State Water Resources Control Board

RESPONSE TO PUBLIC COMMENTS FOR DRAFT STORM WATER RESOURCE PLAN GUIDELINES

Figure 1. Example project "type."

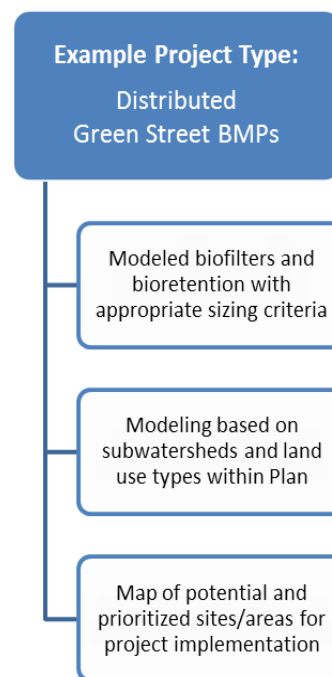
The commenters state that it is not appropriate to set a specific numeric design storm capture performance threshold for a project because: (1) it may be infeasible for water capture projects that deliver many other benefits to achieve an 85th percentile, 24-hour storm capture volume, or (2) an 85th percentile, 24-hour storm capture volume is infeasible for many watersheds throughout the state.

One commenter (*California Water Partnership, CWP 20*) supports the 85th percentile, 24-hour storm threshold, and also suggests that capture of the 95th percentile storm should be encouraged in the Plan Guidelines.

Additionally, the definition of “project” has been clarified in the draft Guidelines; a “project” includes a collective of project activities and programs (such as distributed green streets across a subwatershed) that may collectively capture a storm event volume, rather than on an individual activity basis. The new definition for “project” states the following: *includes “project type” and consists of an entire set or group of opportunities, programs, actions or activities (including structural and non-structural implementation of management measures and practices).*

The Plan Guidelines were revised to clarify that projects included in the Plan may be individual projects or “project types” that will result in the Plan’s proposed watershed outcomes, as demonstrated through a quantitative metric-based analysis in the Plan. Figure 1 was added to the draft Guidelines to further illustrate the newly expanded definition of “project”.
